Project: Taco Bell
1803 Washington Street
Two Rivers, WI

Re: Design Committee Review Comments
Pacific Bells LLC - Taco Bell at 1803 Washington Street

NEW BUILDING FOR: PACIFIC BELLS LLC

CIVIL SITE PLAN

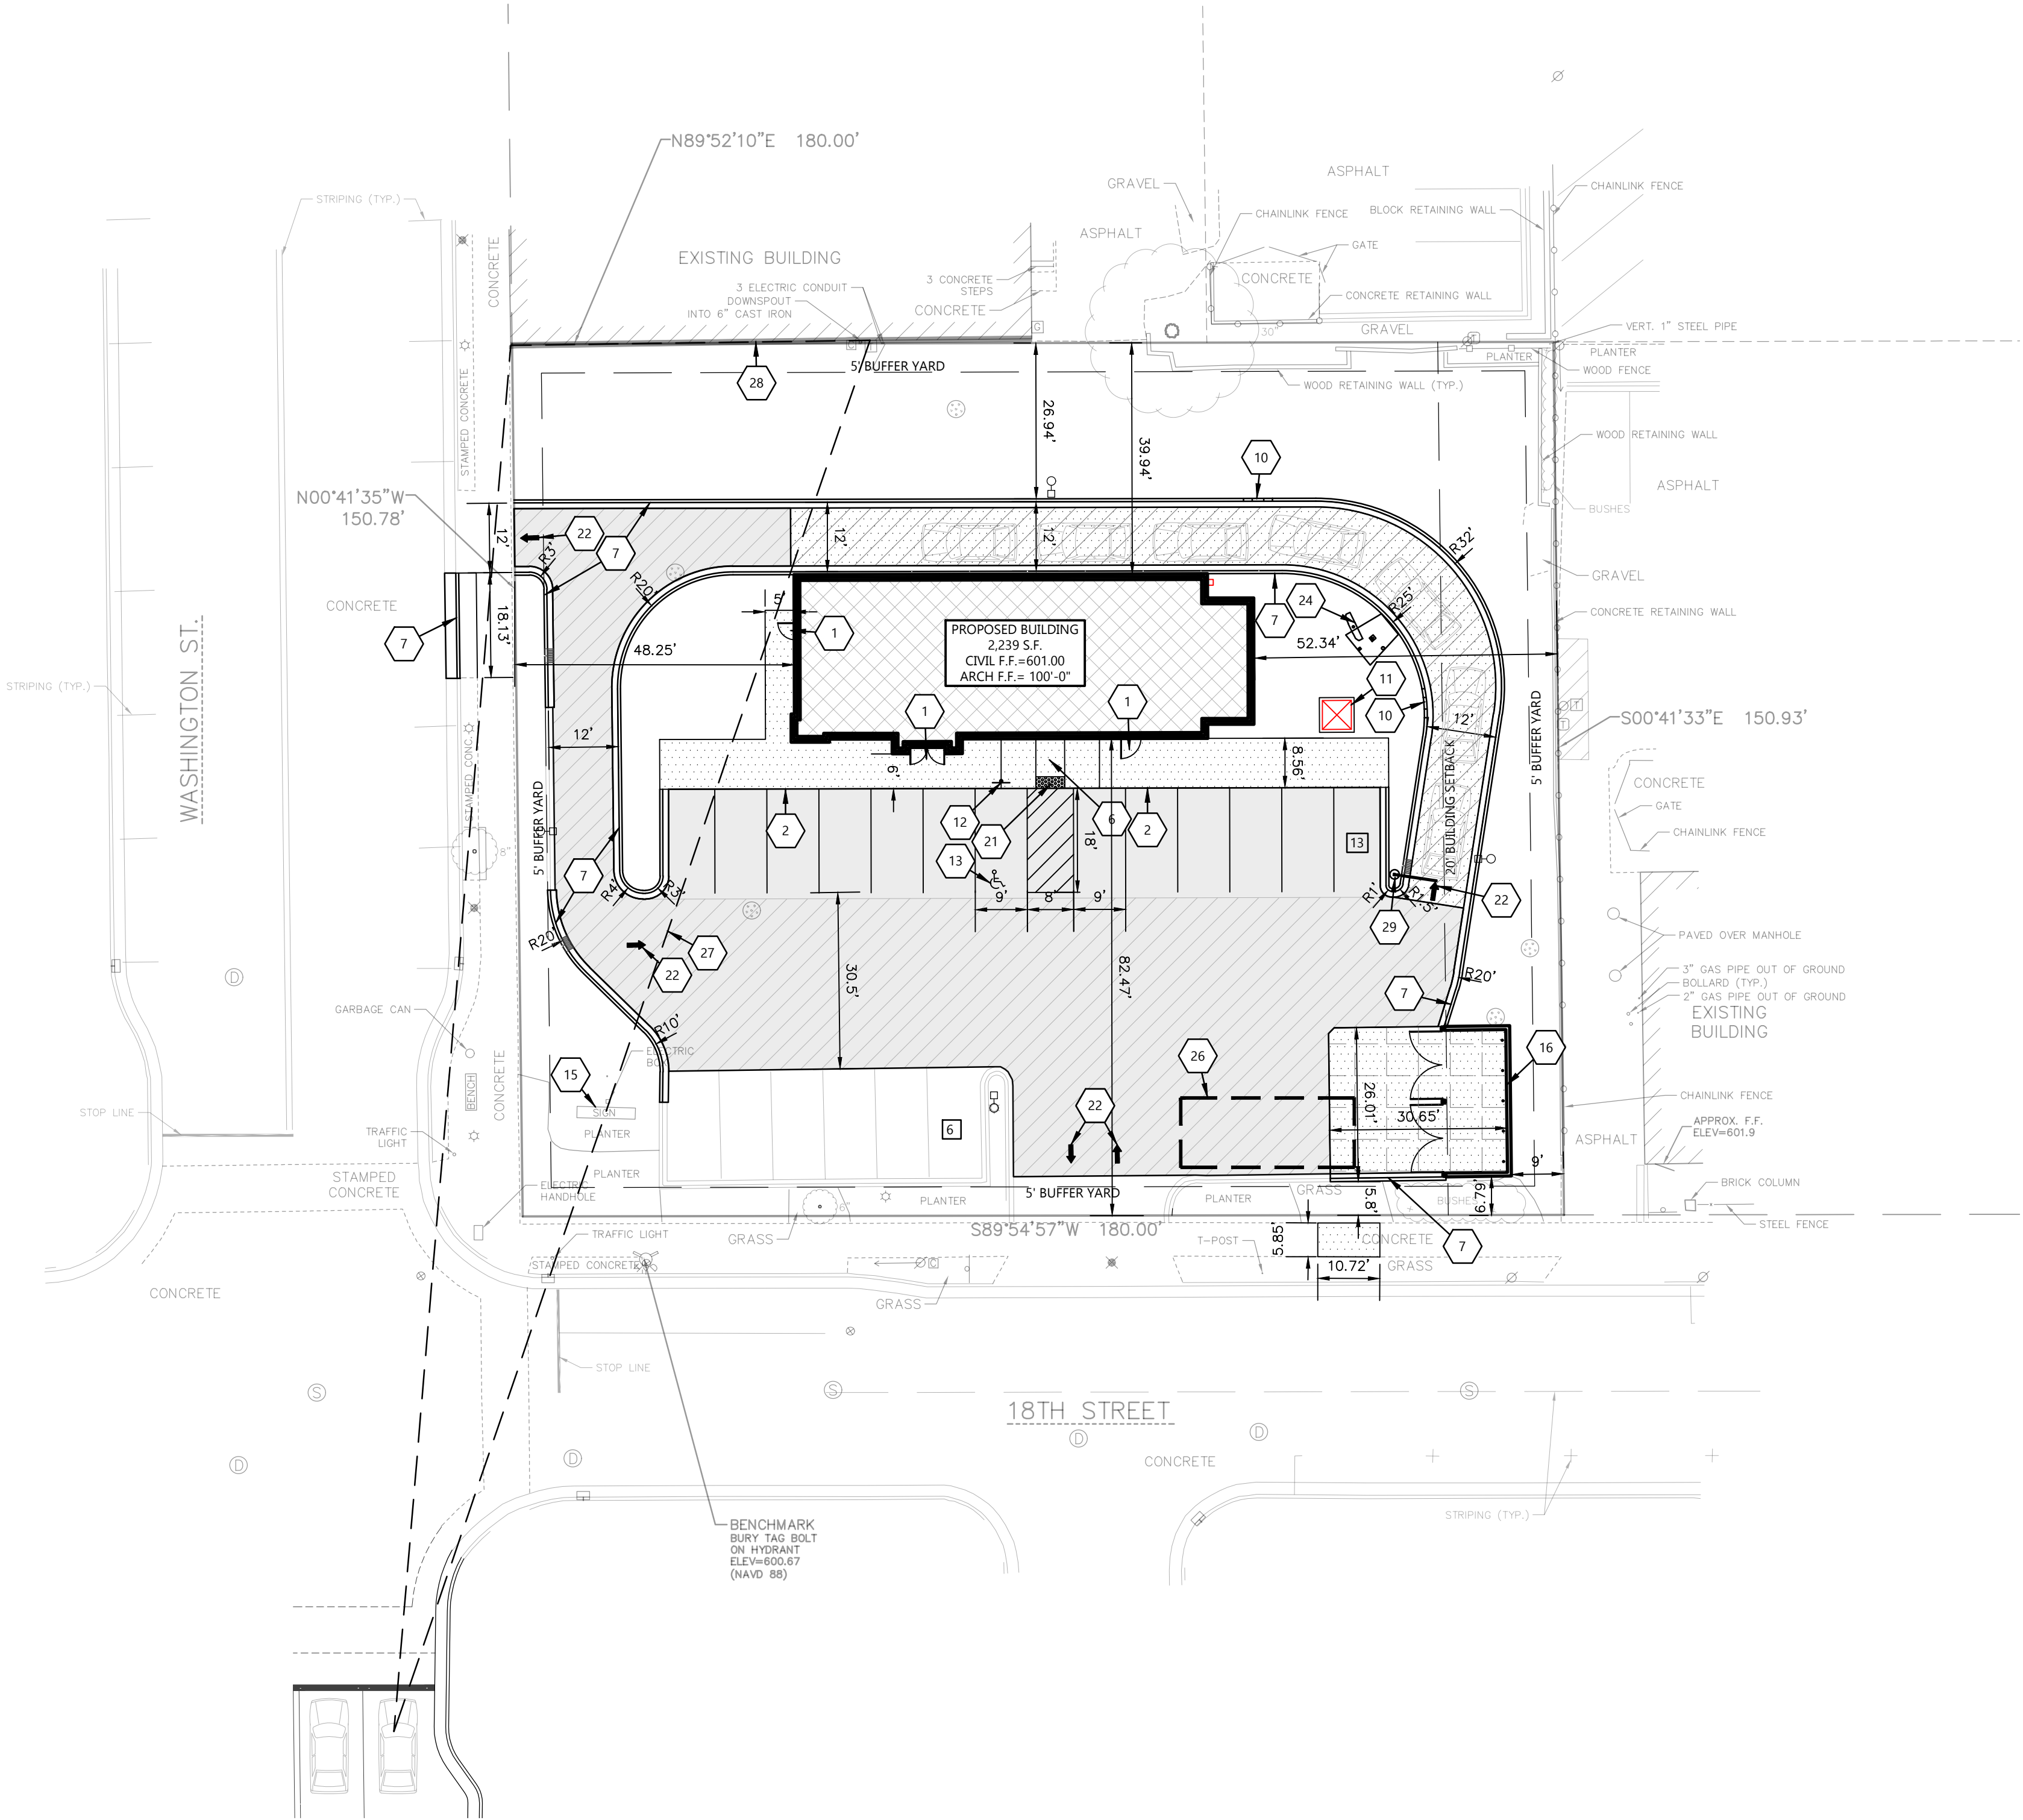
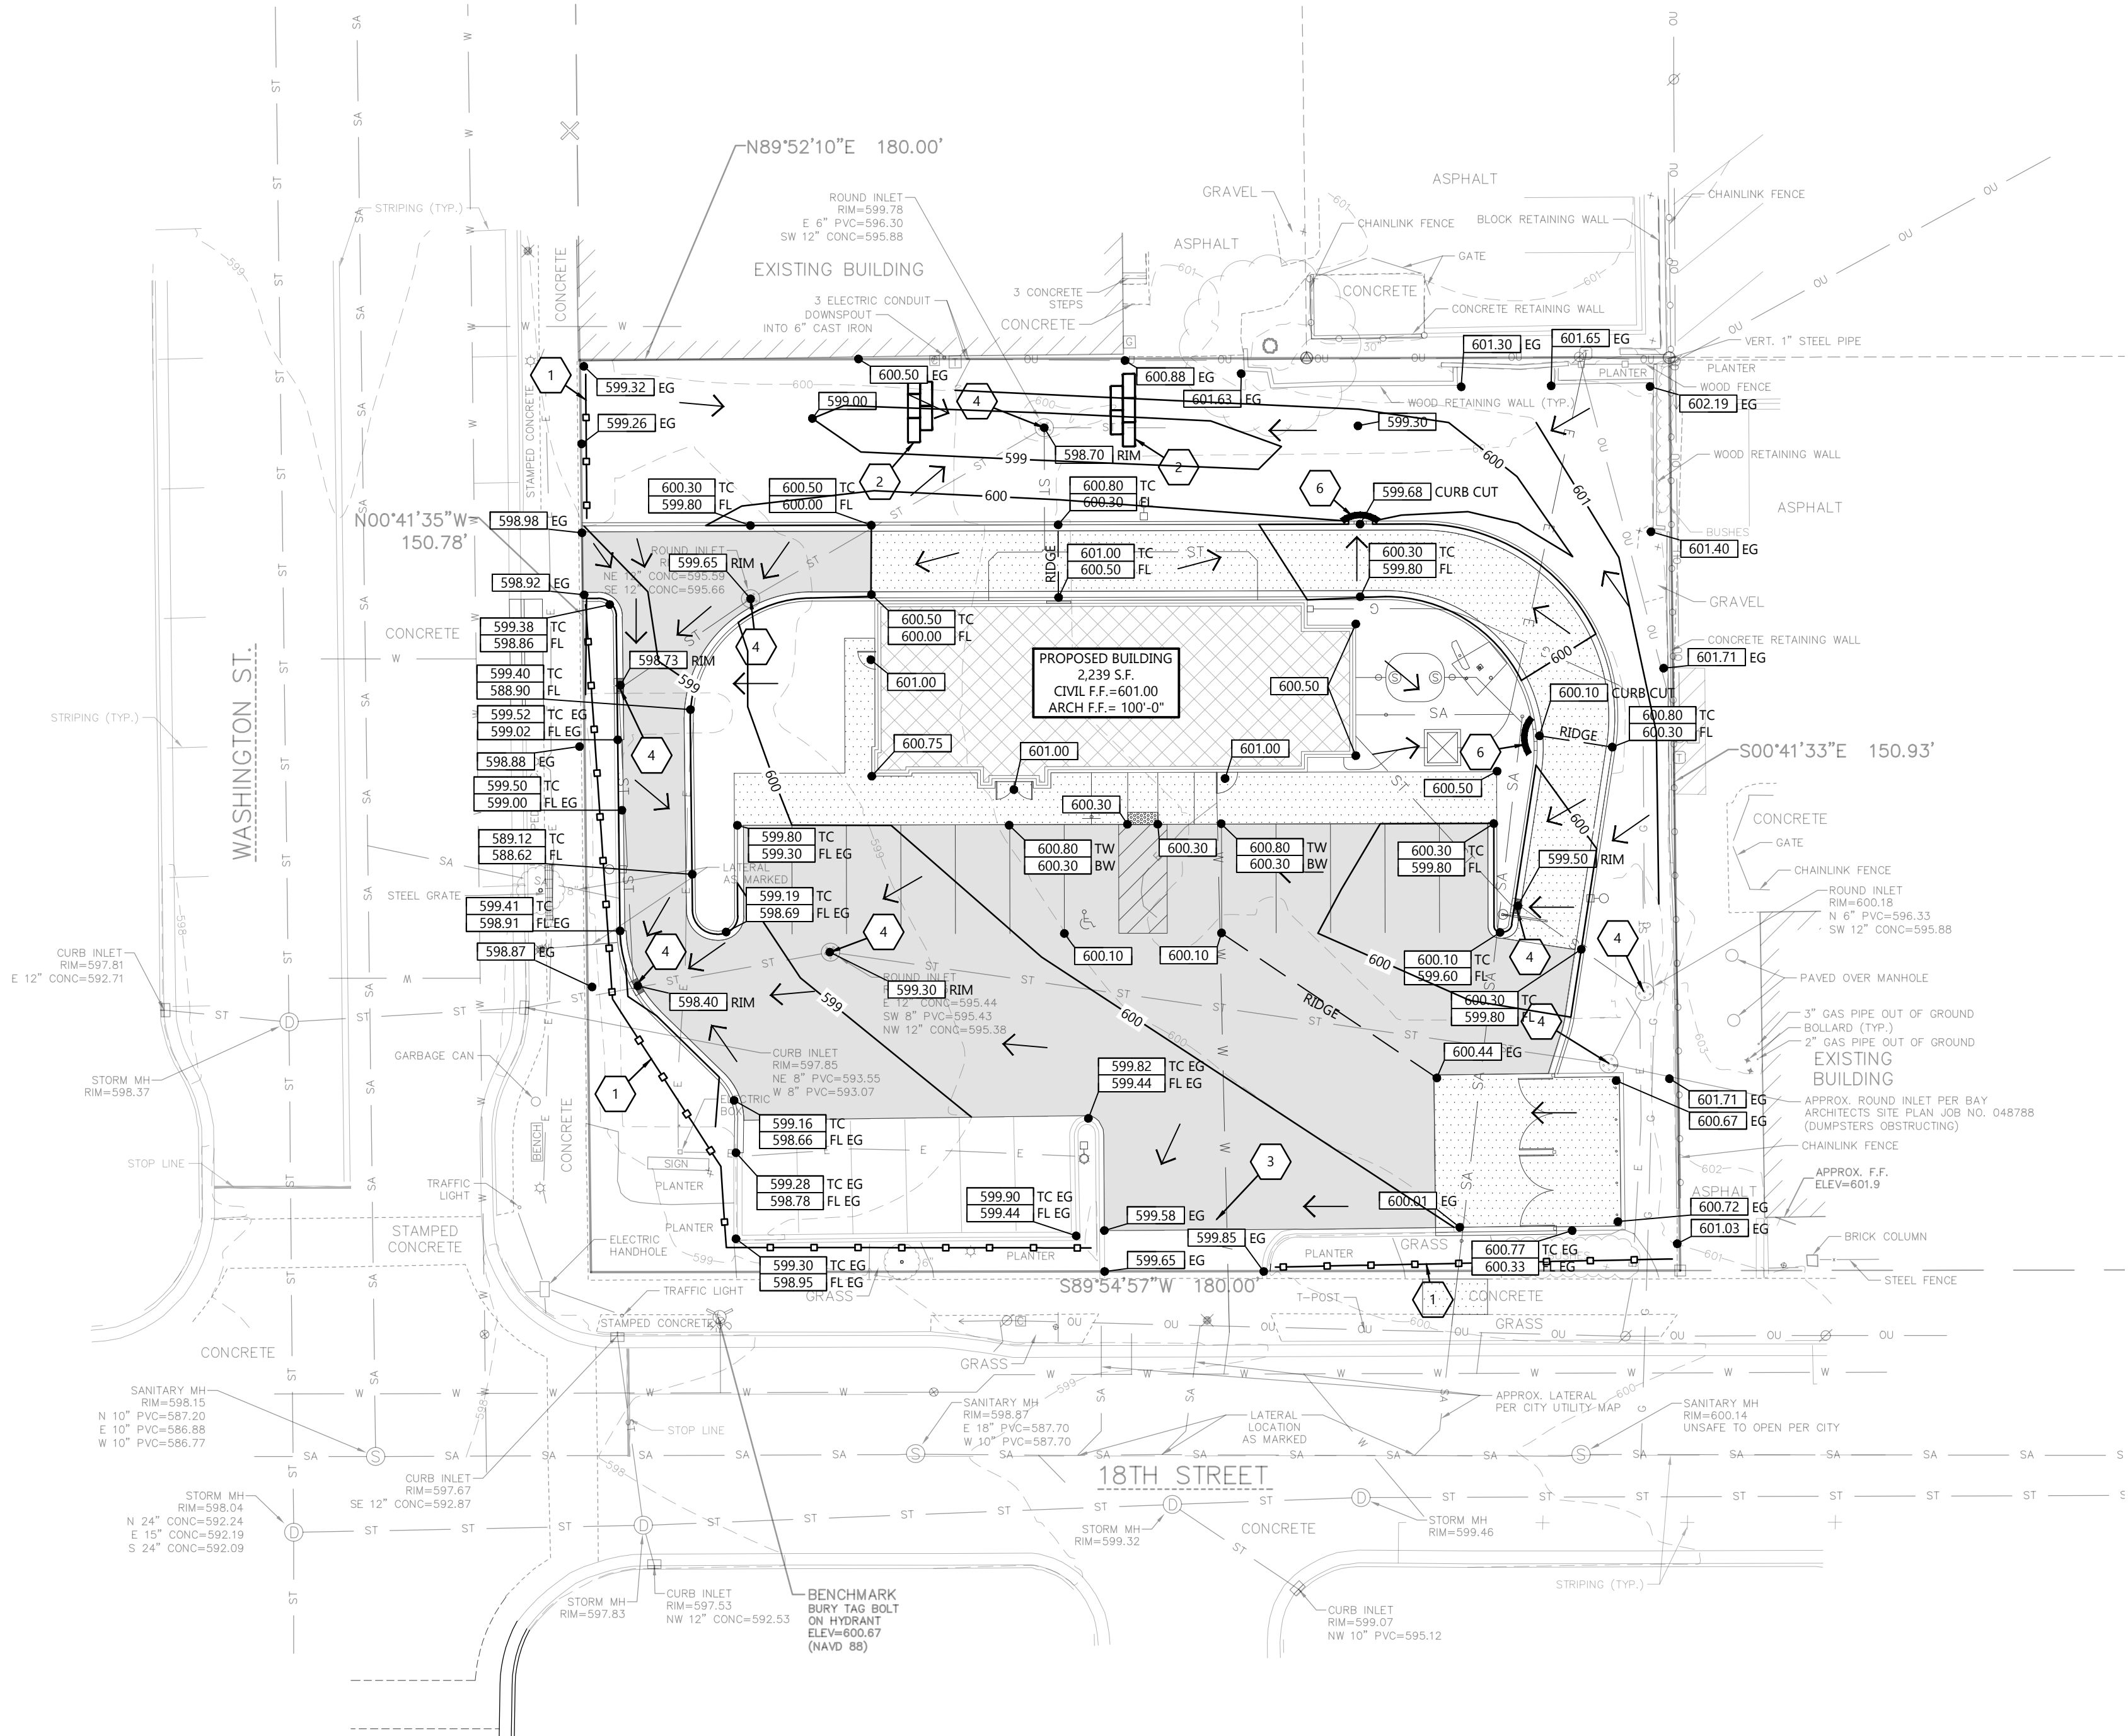
- 1) Committee members expressed concerns regarding the proposed structure blocking the recently installed mural, but noted that the mural would provide a pleasant view for drive through customers. Is there another design that could be substituted? Could the location of the building be shifted or placed on a diagonal?
Excel Response: Shifted the building 10' east to allow the mural to be seen by a stopped northbound car at the intersection of Washington Street and 18th street. See vision triangle on C1.1.

CIVIL SITE PHOTOMETRIC PLAN & DETAILS

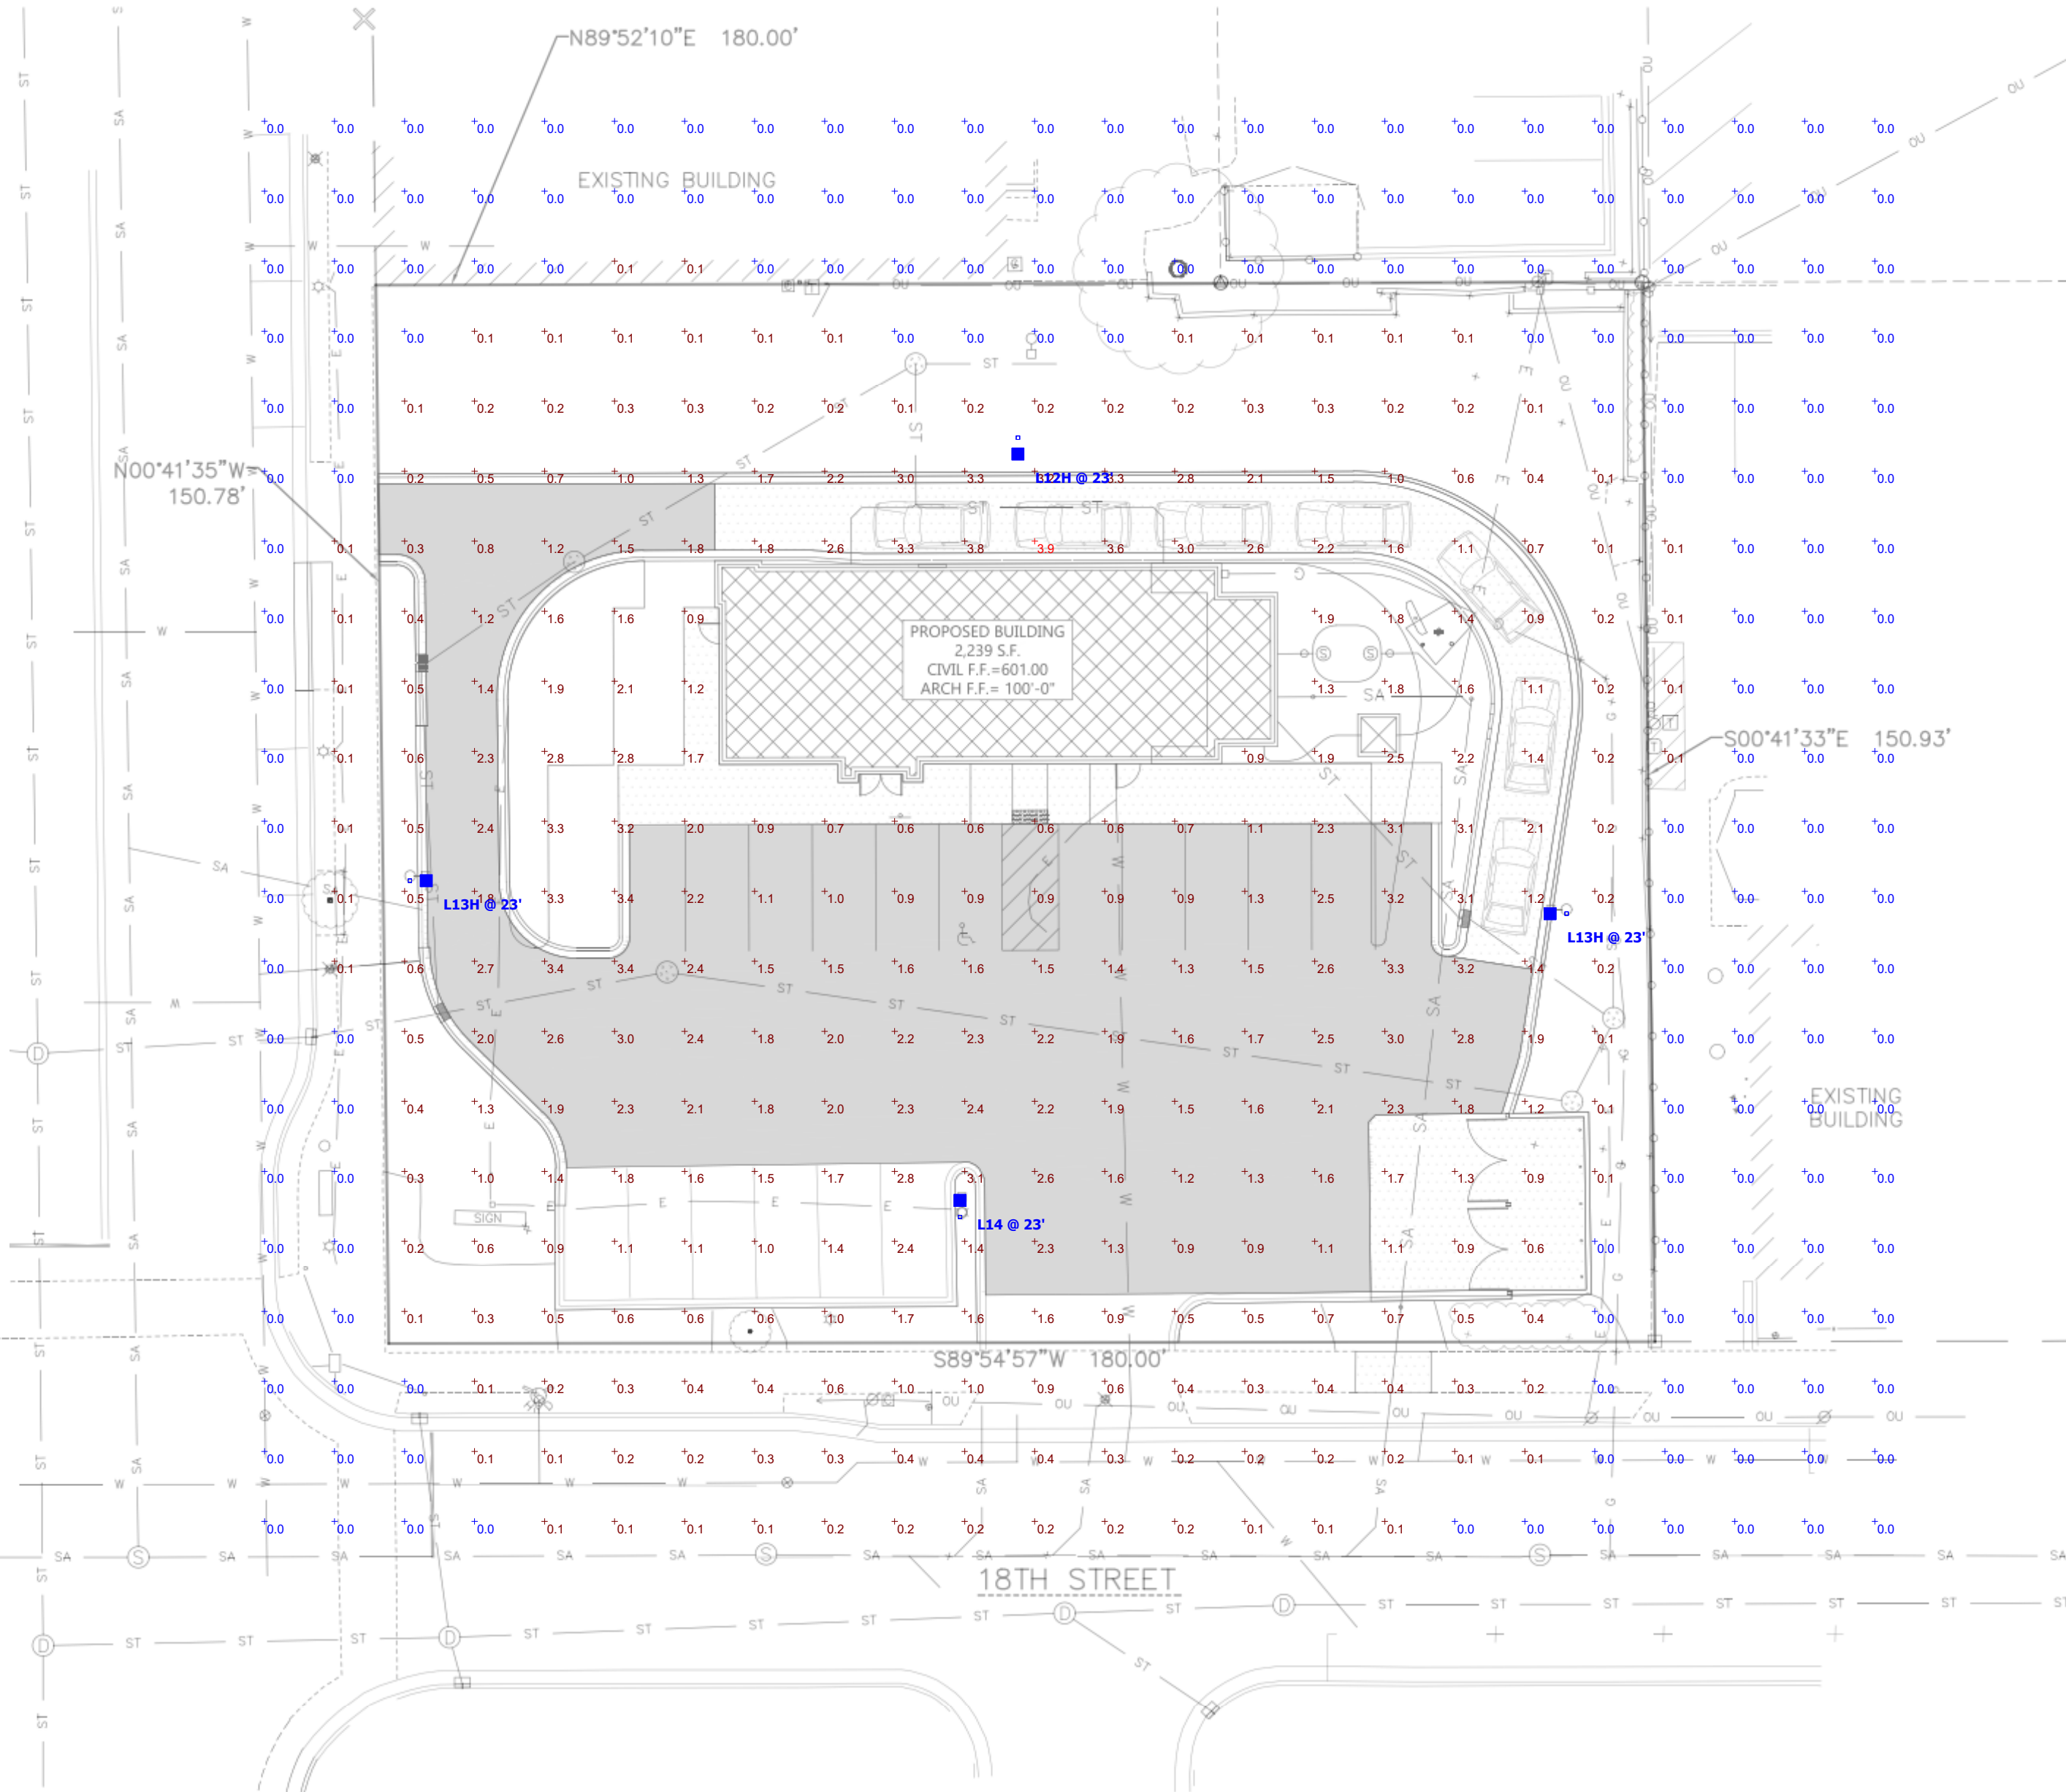
- 4) The committee had some concern regarding the height of the proposed light poles as they relate to existing light poles on Washington Street, but appreciates that they are IDA compliant.
Excel Response: The height of the poles are shown on the site photometric plan (C3.1) at 23'.
